NTD-NRC-96-4622
DCP/NRC0447
Docket No.: STN-52-003

SUBJECT: WESTINGHOUSE RESPONSES TO NRC REQUESTS FOR ADDITIONAL
INFORMATION ON THE AP600

RAI's addressed in the January 12, 1996 submittal:

Figure 440.361-1 Validation of CONTRA Using ANSYS Calculations

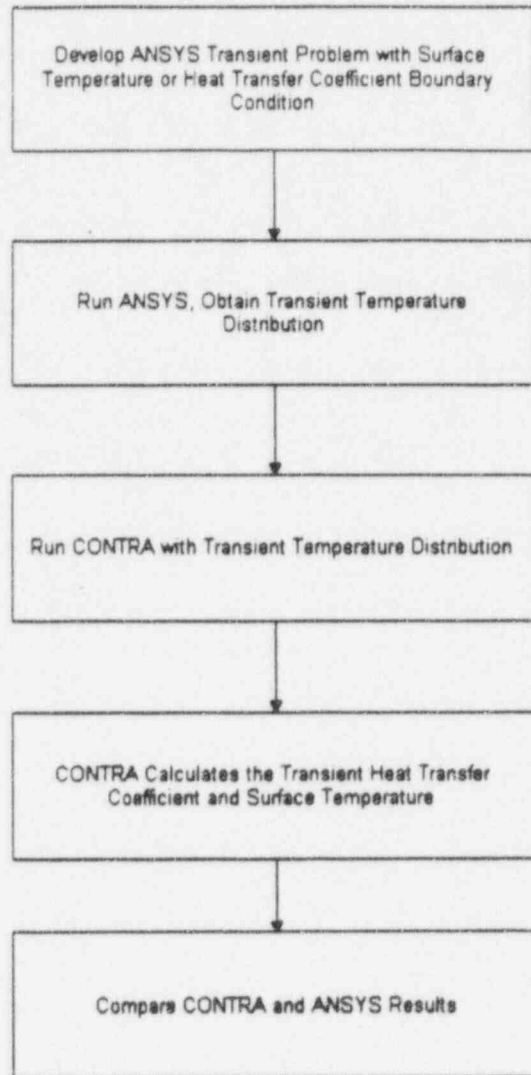
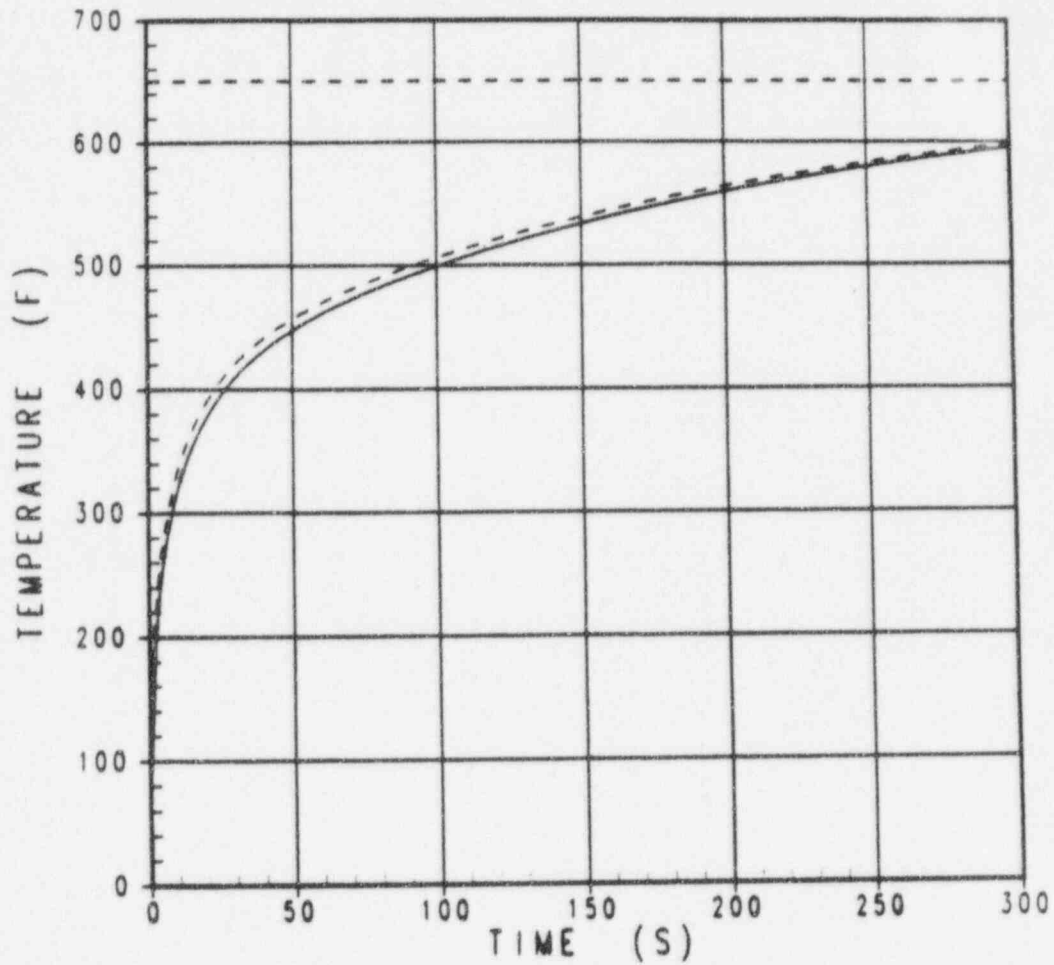
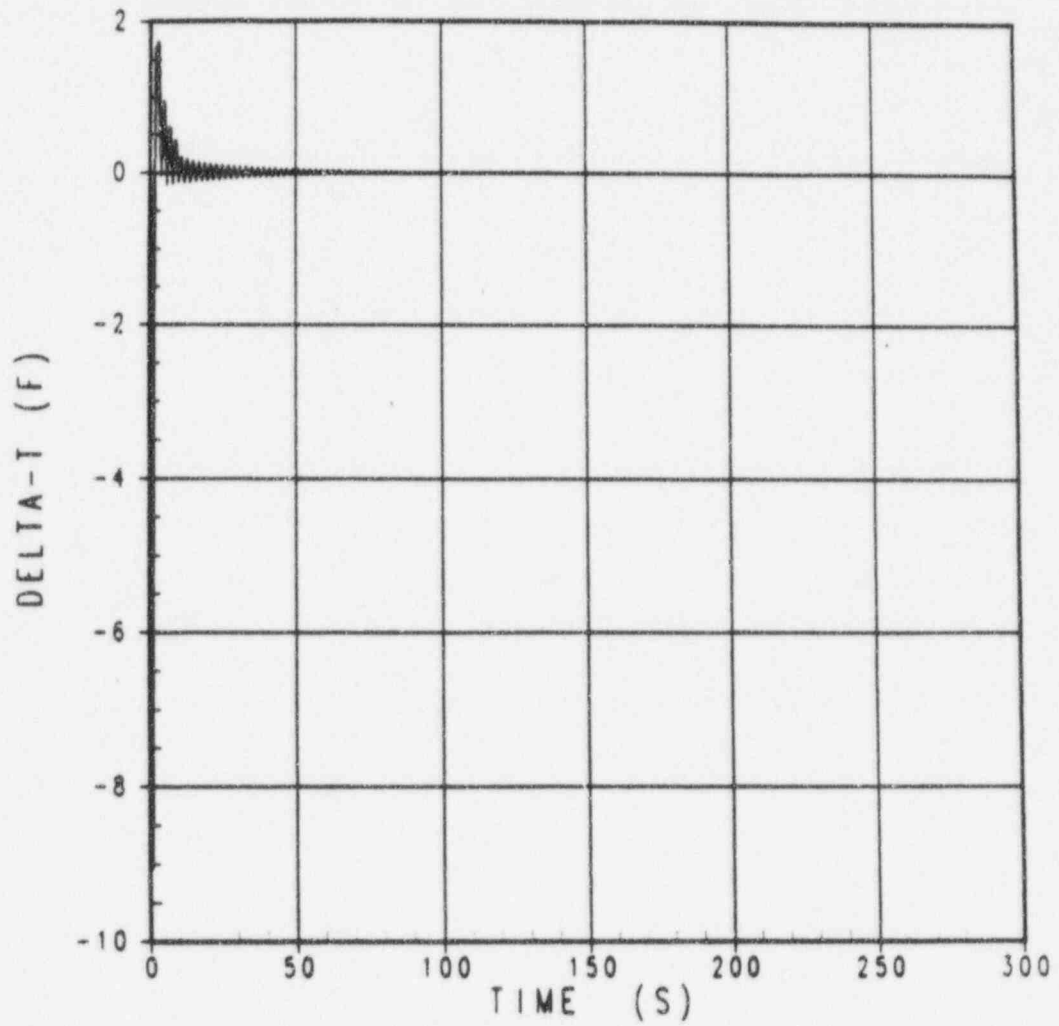
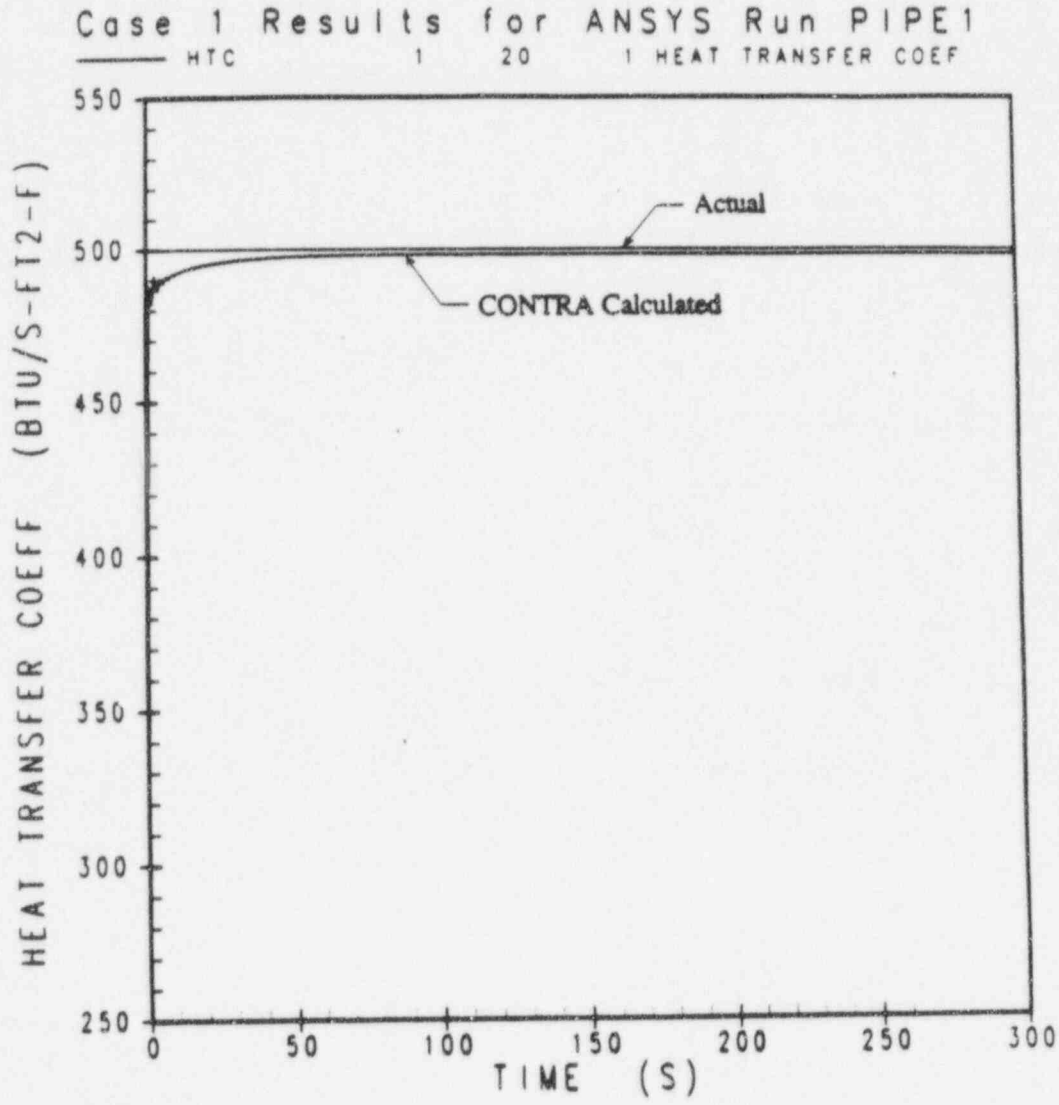
The CONTRA model used by Westinghouse is apparently a modified version of the CONTA model developed by Sandia National Laboratory (SNL). If this is correct, provide documentation describing how the SNL model was modified, validation of the modifications, and benchmarking of the modified model to known heat flux data.

The CONTRA model used in the analysis of the CMT tests is a modified version of the CONTA program which was originally developed by SANDIA. CONTA is written as a one-dimensional rectangular co-ordinate inverse conduction program and a radial inverse conduction program for solid cylinders of infinite length. The changes made were to model an annular geometry in which different time dependent boundary conditions could be imposed on either the inner or the outer surface. The changes to the CONTA program for annular geometries were verified against calculations using the general purpose finite element heat transfer program called ANSYS (Reference 440.361-1). A number of test cases were performed using the ANSYS program with step increases in temperature, or in heat transfer coefficient from a given initial condition. The ANSYS program calculated the transient temperature distribution that was used in the CONTRA program as input data. CONTRA then calculated the wall heat transfer coefficient or surface temperature which had been assumed in the ANSYS calculation. A flow chart of the process is given in Figure 440.361-1. The results of the comparisons for a constant heat transfer coefficient of 500 Btu/hr-ft**2 with a surface temperature ramp from 70 °F to 650 °F are shown in Figures 440.361-2 to 440.361-4. The agreement is excellent indicating that the inverse calculation by CONTRA reproduces the imposed heat flux and heat transfer coefficient for the CMT tests.
